ISSUED FOR s4.55(8)  
LODGMENT

DRAWING TITLE			PROJECT
COVER PAGE			VPM
SCALE	STATUS	NUMBER	REVISION
	s4.55 (8)	A0.00	A

S4.55(8) MODIFICATIONS

VPM  
9-11 VICTORIA PARADE, MANLY, NSW

NORTHEAST ELEVATION

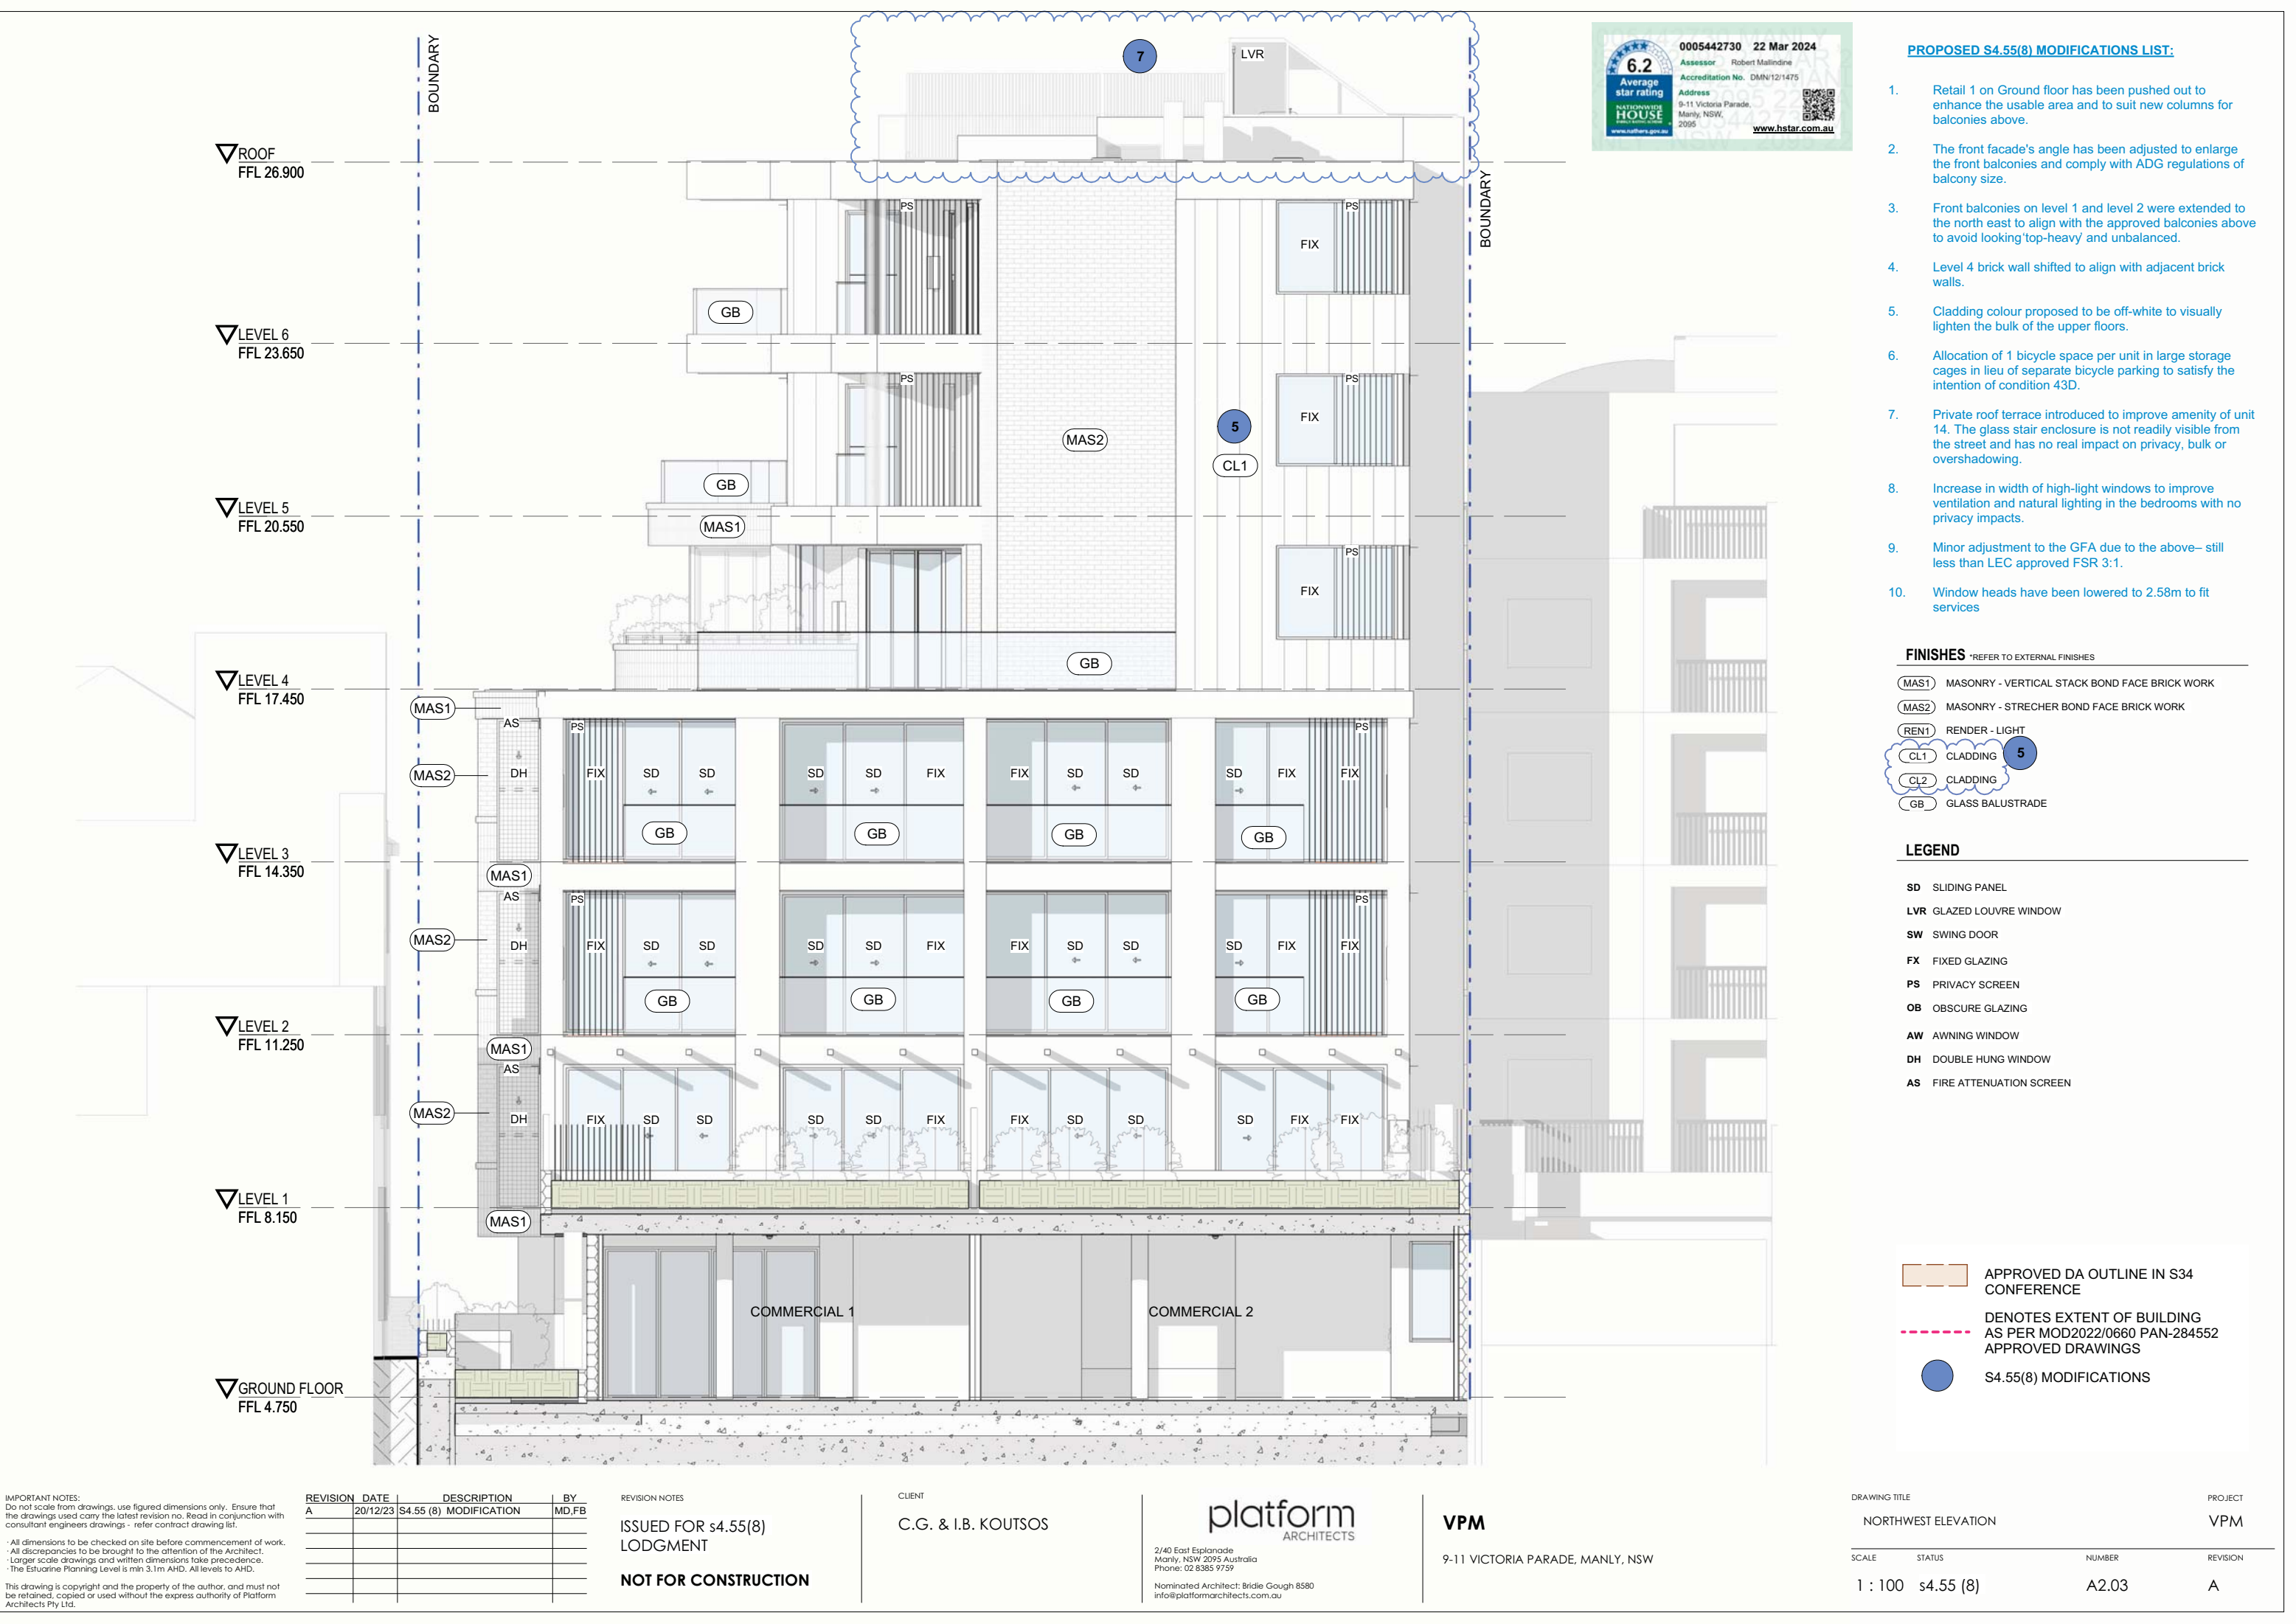
- Retail 1 on Ground floor has been pushed out to enhance the usable area and to suit new columns for balconies above.
- The front facade's angle has been adjusted to enlarge the front balconies and comply with ADG regulations of balcony size.

- Front balconies on level 1 and level 2 were extended to the north east to align with the approved balconies above to avoid looking 'top-heavy' and unbalanced.

- Level 4 brick wall shifted to align with adjacent brick walls.
- Cladding colour proposed to be off-white to visually lighten the bulk of the upper floors.

- Allocation of 1 bicycle space per unit in large storage cages in lieu of separate bicycle parking to satisfy the intention of condition 43D.
- Private roof terrace introduced to improve amenity of unit 14. The glass stair enclosure is not readily visible from the street and has no real impact on privacy, bulk or overshadowing.

- Increase in width of high-light windows to improve ventilation and natural lighting in the bedrooms with no privacy impacts.
- Minor adjustment to the GFA due to the above– still less than LEC approved FSR 3:1.

- Window heads have been lowered to 2.58m to fit services
